CTI 2500P-JACP Janus Application Coprocessor Product Revision History

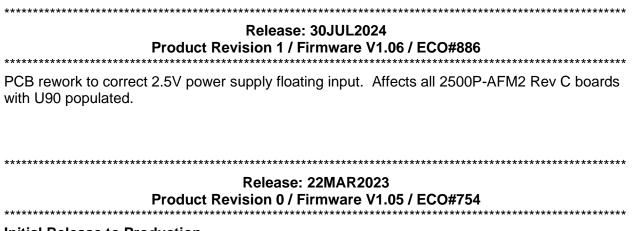
Release: 19AUG2024 Product Revision 3 / Firmware V1.06 / ECO#889		
Change to alternate 2.5V power supply at U96 to eliminate rework.
